# Access Compliance Report

## Public Rights-of-Way

### (Curb Ramps)

Intersection ID: 12013	Main Street: FREEDOM_DR	Cross Street: W_MOREHEAD_ST	Location: E
ADA ID: 0C272DC1128C	Ramp Type: Perp	Initial Pass/Fail: Fail	Overall Compliance: No
		Severity Score: 8.75

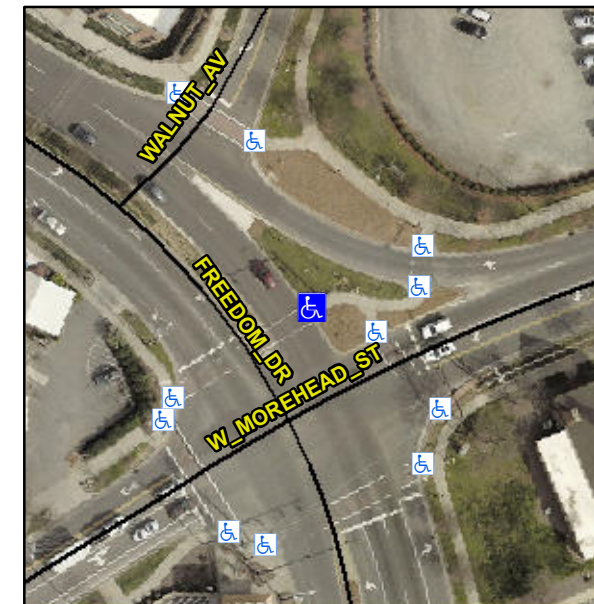
**Not Found, R304.5.1**

Compliance	Description	Data	Compliance	Description	Data
N/A	Ramp Length (in)	72.0	Yes	Ramp Slope (%)	6.4
No	Ramp Width (in)	47.0	Yes	Ramp XSlope (%)	0.1
N/A	Flare Type LT	N/A	N/A	Flare Type RT	N/A
N/A	Flare Slope LT (%)	N/A	N/A	Flare Slope RT (%)	N/A
N/A	Flare Traversable LT?	N/A	N/A	Flare Traversable RT?	N/A
N/A	Landing Length (in)	N/A	N/A	DWS Provided?	N/A
N/A	Landing Width (in)	N/A	N/A	DWS Contrast?	N/A
N/A	Landing Slope (%)	N/A	N/A	DWS Length (in)	N/A
N/A	Landing X Slope (%)	N/A	N/A	DWS Full Width?	N/A
N/A	Landing Curb? (Y/N)	N/A	N/A	DWS Offset (in)	N/A
N/A	Shared Landing?	N/A			
N/A	Gutter Ponding?	N/A	N/A	Gutter Slope (%)	N/A
N/A	Gutter Lip Ht (in)	N/A	N/A	Gutter X Slope (%)	N/A
N/A	Painted X Walk1?	Yes	N/A	Painted X Walk2?	N/A
	X Walk 1 Direction	To W		X Walk 2 Direction	N/A
N/A	X Walk 1 Width (in)	114.0	N/A	X Walk 2 Width (in)	N/A
	X Walk 1 Slope (%)	3.9		X Walk 2 Slope (%)	N/A
	X Walk 1 X Slope (%)	0.4		X Walk 2 X Slope (%)	N/A

**Remove & Replace Entire Ramp.**
